In The Matter Of:
75 HOWARD STREET
DRAFT EIR

ON THE DRAFT ENVIRONMENTAL IMPACT REPORT

Item E. 13. 2011.1122E

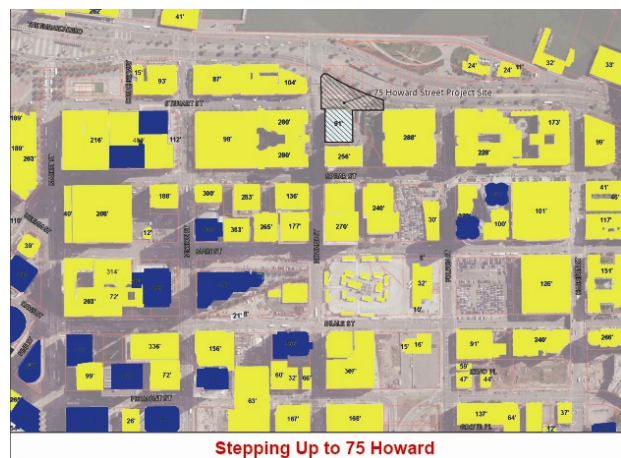
Comparing the height of a project like this with the heights of neighboring buildings is a critical component of an EIR. However, it’s as though this DEIR seems to be comparing the heights of circles and boxes. 75 Howard is very boxy, but many of the neighboring buildings taper to narrow spires. Rincon Center, for example, is topped with four spires above two domes (or barrel

vaults) that curve upwards to peaks. Unfortunately, the DEIR compares the height of 75 Howard's nearly flat top with the heights of the other buildings' narrow tops. (The tops of Rincon's domes and spires are insignificant when gauging height.) These references need to be corrected.

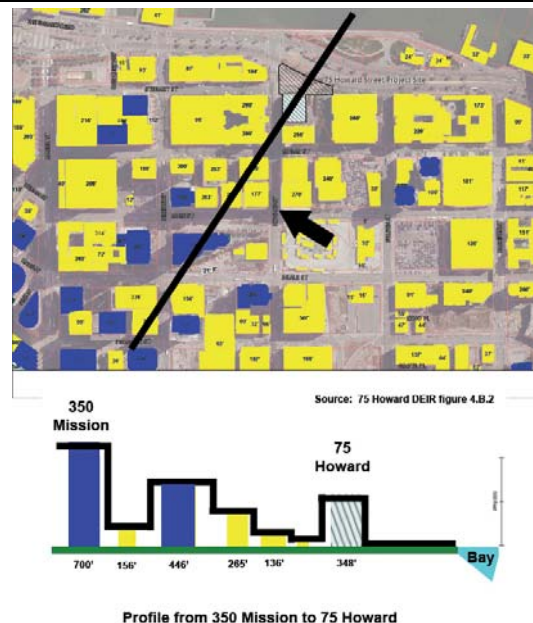
To better gauge and quantify whether a project meets the step-down requirements, the DEIR should use the following two tools:

- One, simply count the number of higher and lower buildings within various perimeters around the project. This method makes it clear that the 75 Howard project is surrounded primarily by shorter buildings all around.
- Two, create profiles or cross sections of area buildings on straight lines fanning out between 45- and 135-degrees from the project. We believe most of these will clearly show buildings stepping down before the project. 75 Howard then creates a big step up and then a 348-foot step almost straight down.
